October 22, 2010

ENERGY STAR Luminaires Draft 2 Comments

**Page 32 / Solid-State**

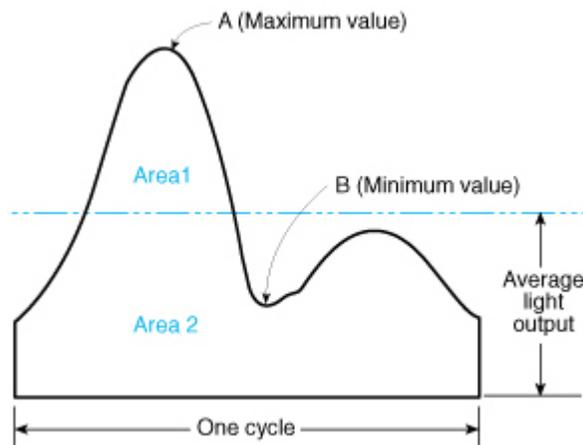
The phrasing as presented indicates that SSL products will be required to meet (2) separate criteria:

$\geq 120\text{Hz}$  and modulation depth of  $< 50\%$

There are five specific issues with this as written that need to be addressed in order to make any definition or standard intended to address flicker that are not effectively represented by the standard as written:

**Issue One:** The use of modulation depth is an obsolete standard, abandoned by the IES for a more meaningful Flicker Index. Modulation depth fails to recognize the effect of duty cycle (modulation emission width), therefore does not represent an accurate metric for determining lighting quality.

**Issue Two:** The Flicker Index does not reflect or include any representation of modulation frequency. Considerable research has proven that as frequency increases, human perception and sensitivity to flicker, in both visible and non-visual response is decreased. There has been no evidence indicating that modulation of any type is problematic in either perception or impact on human health at frequencies >2KHz. Therefore, any additional cost or effort on the part of manufacturers to meet both the modulation frequency and Flicker Index requirement over 2KHz is a wasted effort and likely to add cost unnecessary to the proper and satisfactory function of the end product.

**Issue Three:** The issue of perceived flicker has been studied and proven to be highly dependent on visible source brightness and emission source size. The higher the brightness in contrast to background luminance, the greater the perception of flicker will become. Failure to address this dynamic for an overly simplistic frequency/Flicker Index value standard will likely lead to products utilizing highly visible LED sources to gain optimal efficiency, that are both glare inducing, and aggravating of the flicker issue. This is particularly important for task lighting and directional products, and for products that may be viewed at unexpected viewing angles, such as children looking upward into under-cabinet lighting employing exposed discrete LED sources.

**Issue Four:** The simplistic definition of Flicker Index and Frequency fails to recognize that in non-rectified AC LED arrays that operate  $\frac{1}{2}$  of LEDs on one side of the 60Hz sine wave, and the other on the flip side, sources must be in close enough proximity to be integrated in the eye. If a luminaire simply utilizes (2) LEDs, separated by a distance large enough to preclude integration, the standards will have been met, as measurement equipment will not reflect this separation effect, while the end product generates a visible flicker to human observers of 60Hz, regardless of Flicker Index.

**Issue Five:** There has been no industry level standard or recommendation for flicker characteristics at frequencies greater than 100Hz, agreement on specification of flicker to mitigate impact on human health, or conclusion as to the actual visibility of flicker at 120Hz using LED sources, Therefore, inclusion of the metric as written is premature and unfounded on accepted or industry agreement.

Based on this, a maximum Flicker Index of 0.130 should be established.

Based on this, ONLY products operating between 120Hz and 2KHz should be required to comply with a Flicker Index maximum of 0.130.

Retain the standard of Flicker Frequency of  $\geq 120\text{Hz}$  based on photometric measurement, and eliminate all other metrics referenced. Redress the metrics when the work of the IES, IEEE, and other organizations addressing flicker is complete and objectively defined.

Maintain the  $\geq 120\text{Hz}$  requirement, and add more comprehensive definition of flicker that reflects known information and research on the topic as follows:

For all AC and DC products operating at  $\leq 2\text{KHz}$  recommend the following additional requirements be established:

Maximum Flicker Index  $\leq 0.130$

Establish a minimum spacing between individual die or individual light sources is close enough to facilitate visual integration (suggest no greater than 2mm in any direction.)
